Site Accessibility Evaluation

Americans with Disabilities Act Title II (Public Services: State and Local Government)

Pikes Peak Center

***Inspection Date: 04/10/2018
Inspector: David Mejia***

Finding: 1

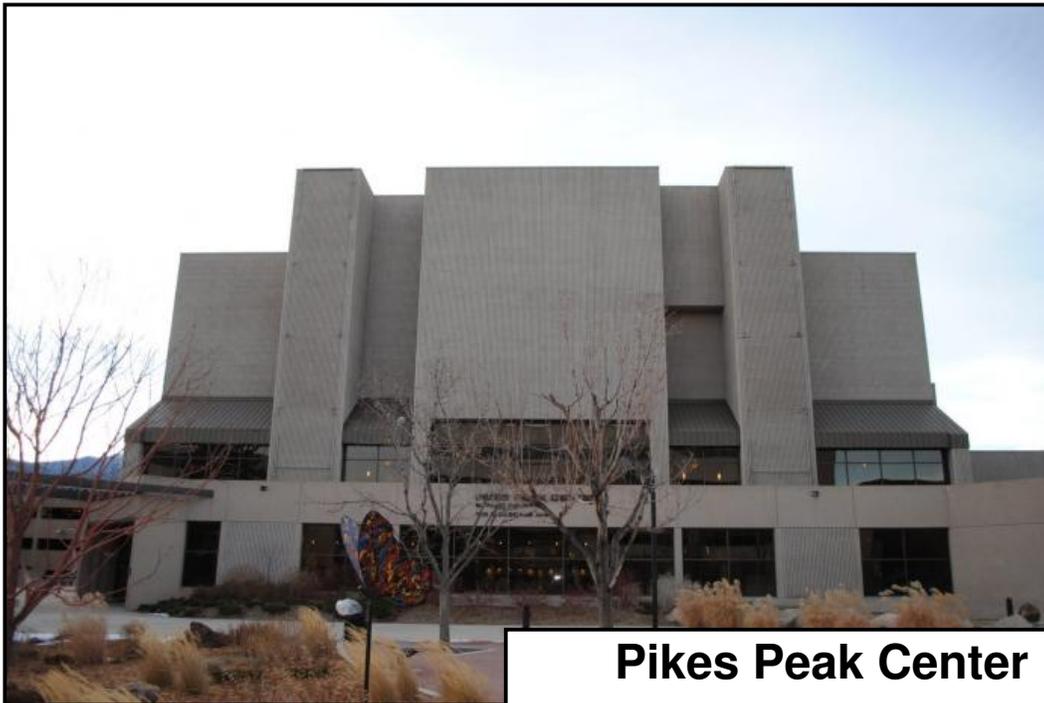
The passenger drop-off and loading area is not accessible.

Drop-off and loading zone shall provide an access aisle at least 60 inches wide and 20 feet long adjacent and parallel to the vehicle pull-up space. The vehicular pull-up space must be 96 inches wide minimum and 20 feet long minimum. Access aisles shall adjoin an accessible route and shall not overlap the vehicular way. Vehicle standing spaces and access aisles shall be level with surface slopes not exceeding one unit vertical in 48 units' horizontal (2-percent slope) in all directions. If there are curbs between the access aisle and the vehicle pull-up space, a curb ramp shall be provided. Each passenger drop-off and loading zone designed for persons with disabilities shall be identified by a reflectorized sign permanently posted immediately adjacent to and visible from the passenger drop-off or loading zone stating "Passenger Loading Zone Only" and including the International Symbol of Accessibility, in white on dark blue background.

*2010 ADAS Section 503.1
Passenger loading zones shall comply with 503.*

Area was wide enough, but not marked.

1. Stripe area to designate accessible drop-off and loading zone and two permanent Van Accessible stalls as depicted on attached map. 2. Add ISA signage as depicted on attached map. 3. Add directional signs to Box Office and Studio Bee as depicted on attached map.

Finding 299427 Main Photo

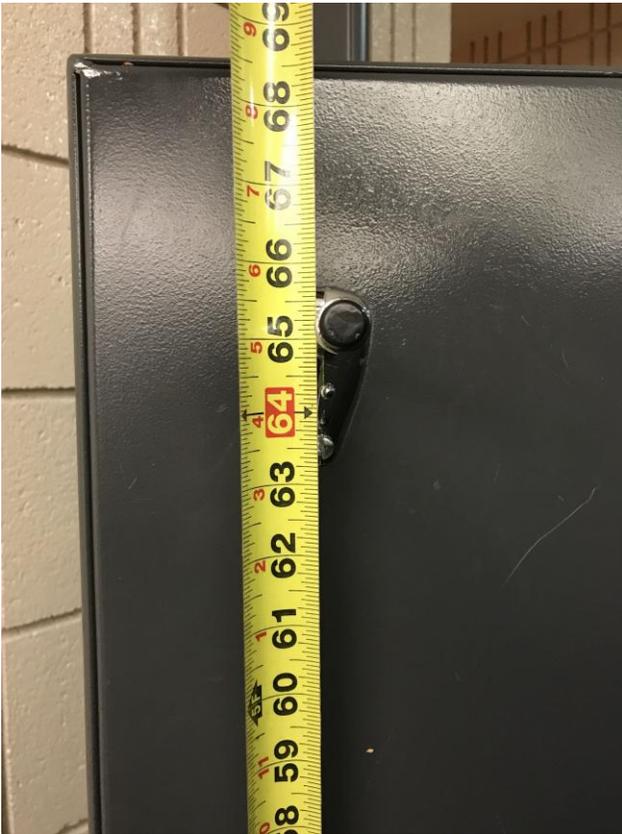
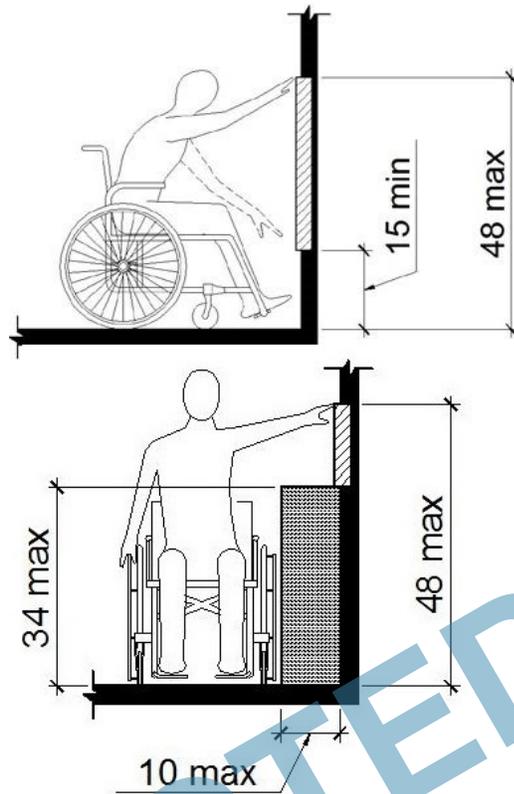
Considered
Unobstructed

CORRECTED

Finding 299423 Main Photo

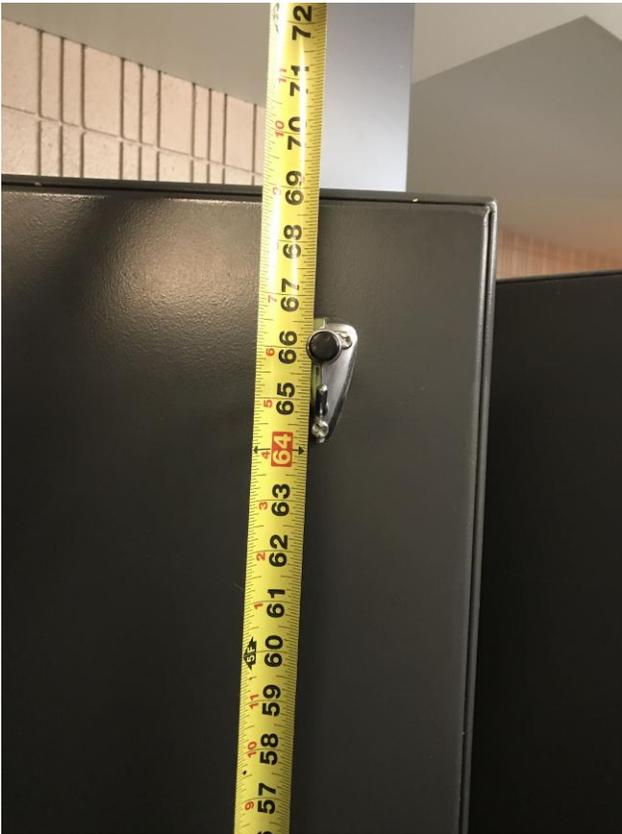
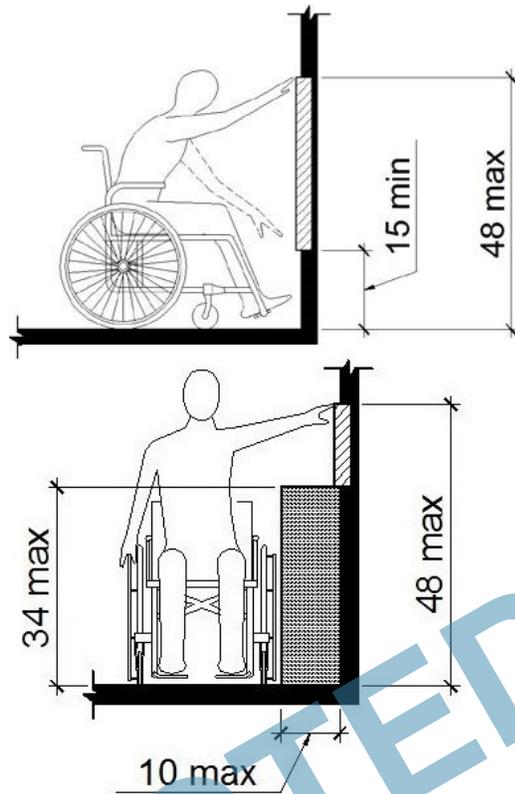
Considered
Unobstructed

CORRECTED

Finding 299005 Main Photo

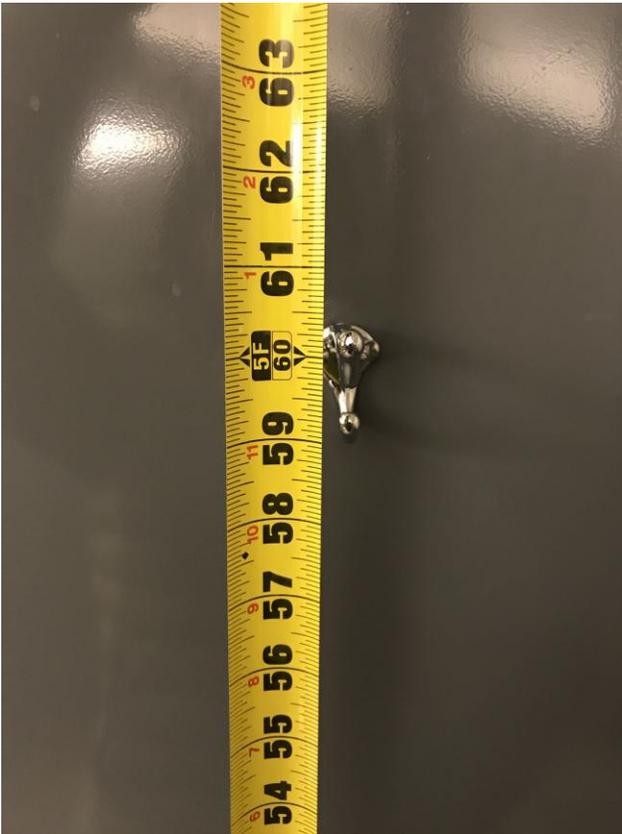
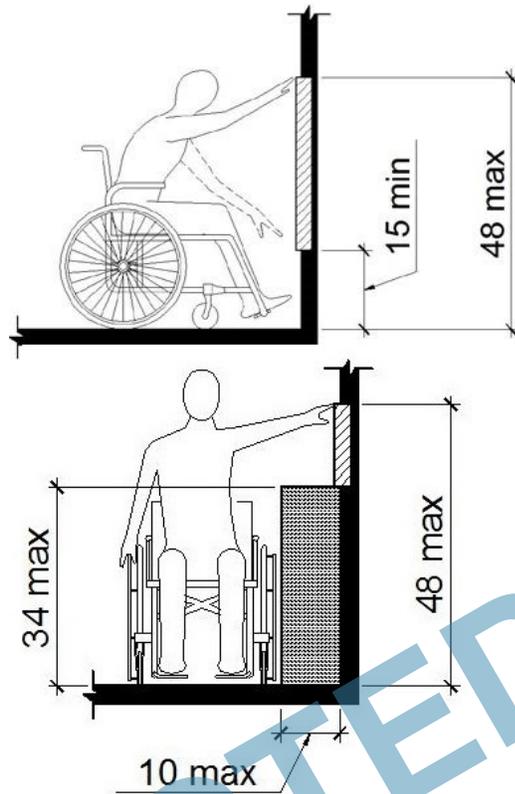
Considered
Unobstructed

CORRECTED

Finding 299012 Main Photo

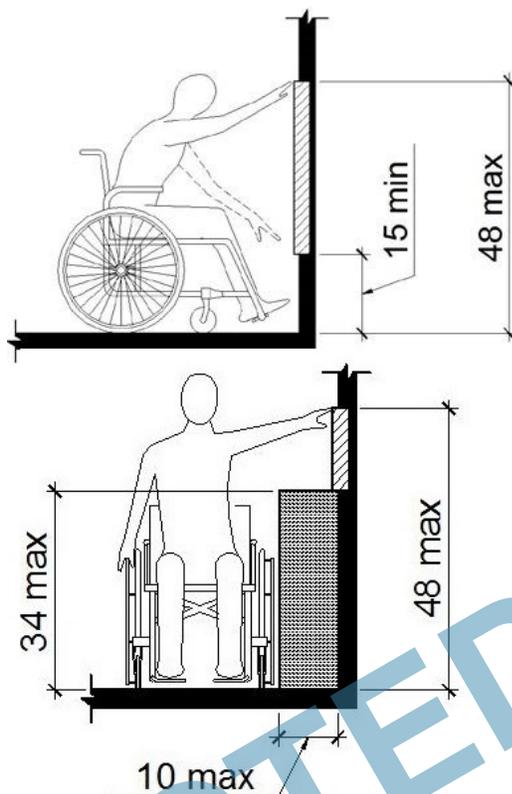
Considered
Unobstructed

Finding 299441 Main Photo

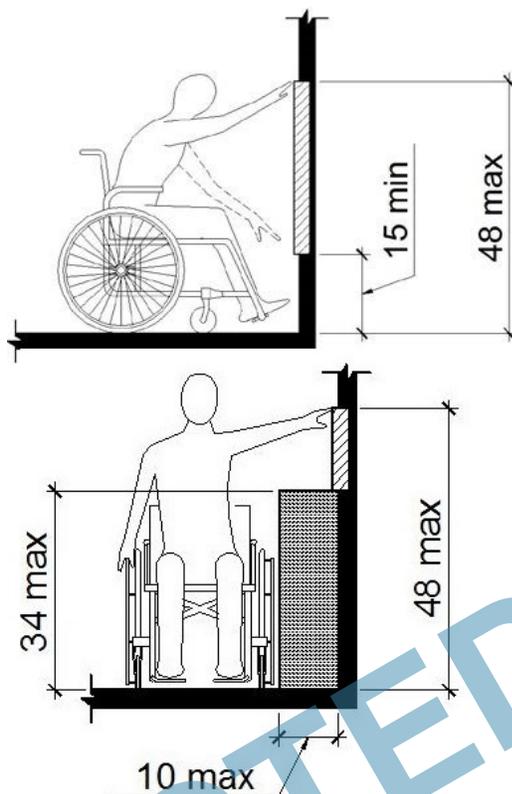
Considered
Unobstructed

Finding 299457 Main Photo

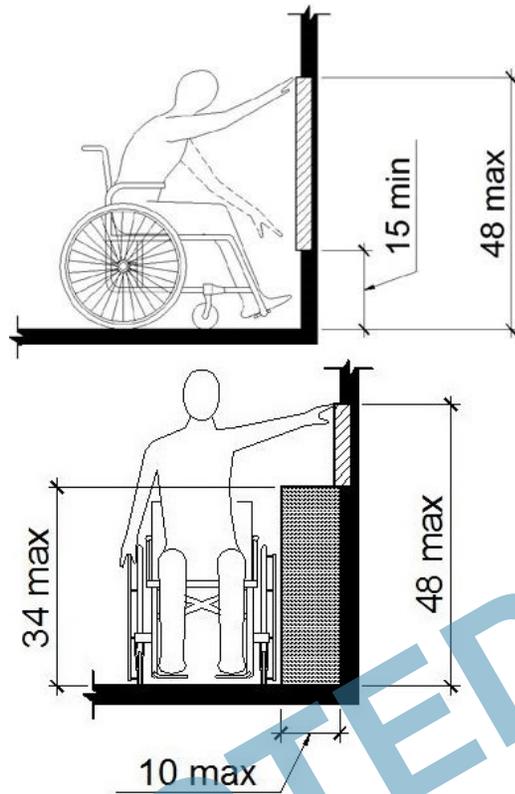
Considered
Unobstructed

CORRECTED

Finding 299452 Main Photo

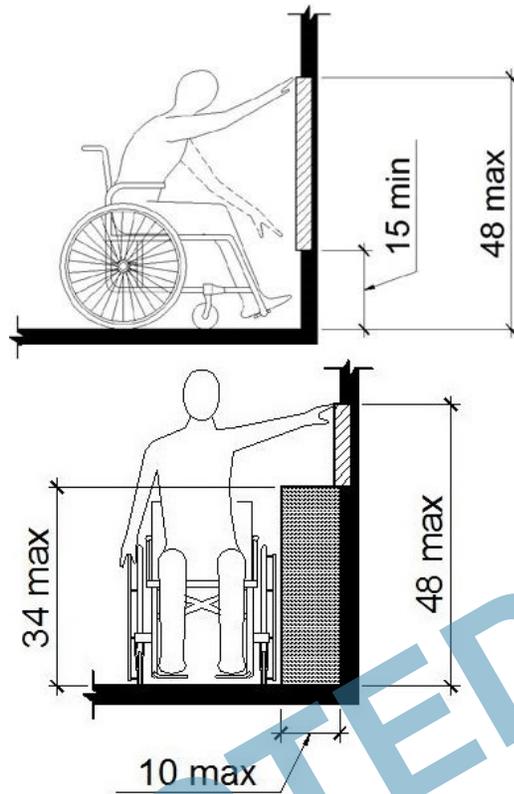
Considered
Unobstructed
